UNITED STATES ENVIRONMENTAL PROTECTION AGENCY  
REGION IX  
215 Fremont Street  
San Francisco, Ca. 94105

MEMORANDUM

SUBJECT: Ordot Landfill--Proposed Remedial Action Plan

**TOPOGRAPHIC  
OF  
GUAM  
MARIANA ISL.**

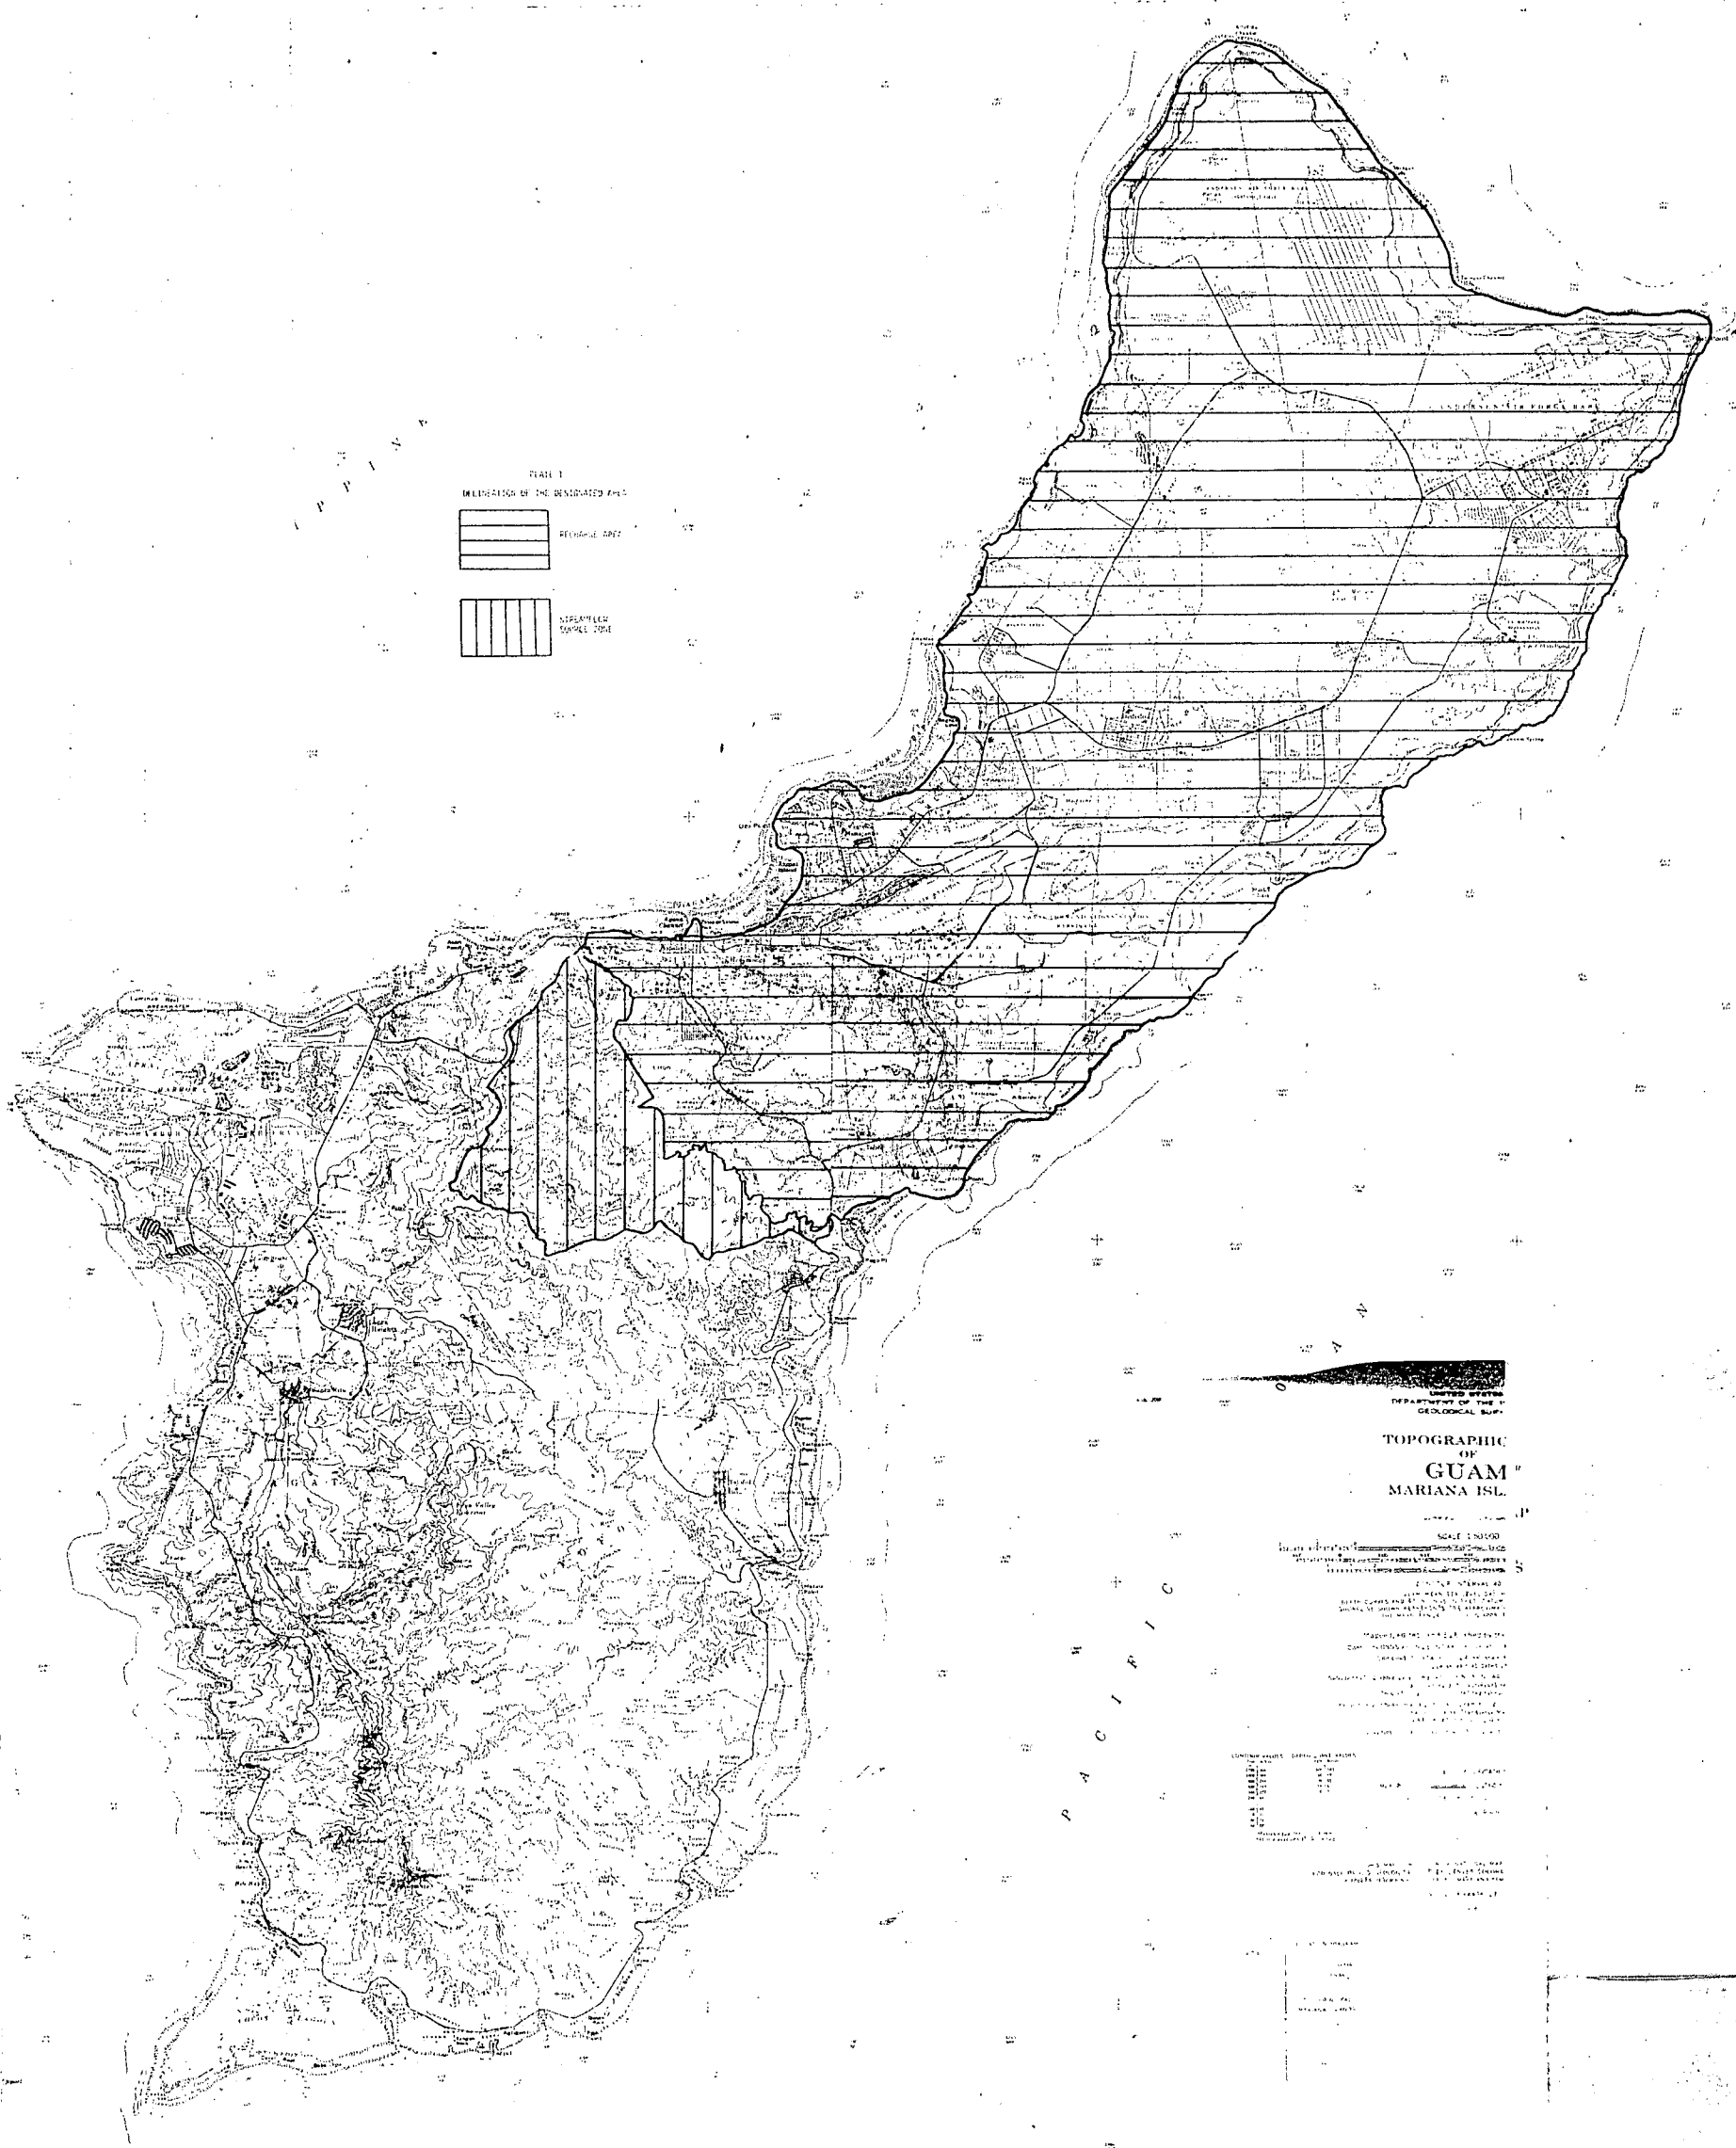
The proposed remedial action plan states that this site is isolated from the designated sole source aquifer. The Federal Register Notice for the Guam Sole Source Aquifer Designation (43 FR 17868) states that both the recharge zone and streamflow source zone (i.e., portions of the Pago and Fonte River basins south of the Adelop-Pago fault) are included in the designated aquifer. According to the map of this aquifer (see attached), the Ordot Landfill appears to be located in the streamflow source zone and therefore, is within the boundary of the designated sole source aquifer.
